Amendments to the Drawing

Remarks

ser. 10/613, 019
mark-up sheet

**Fig. 33(d)
Prior Art**

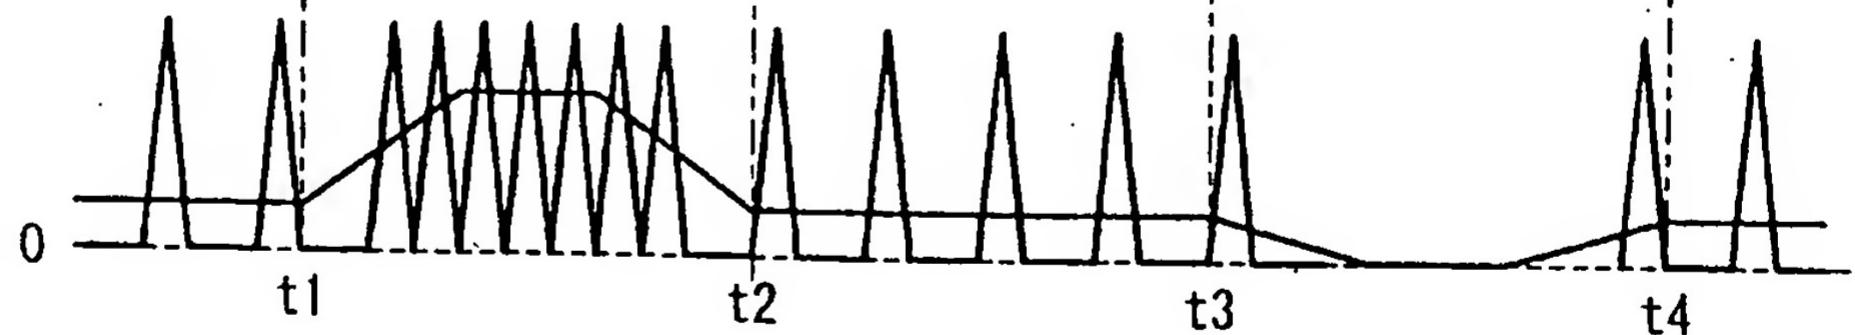
In Figs. 33(a) to 33(d), one of the drawings originally shown was not labeled, and the locations of Figs. 33(b) to 33(d) were incorrect. Therefore, the locations of Figs. 33(b) to 33(d) have been corrected, and label of Fig. 33(e) has been added.

In regard to Figs. 33(a) to 33(d), although five drawings are shown in one sheet, labels of Figs. 33(a) to 33(d) were indicated. Figs. 33(a) to 33(e) should be labeled.
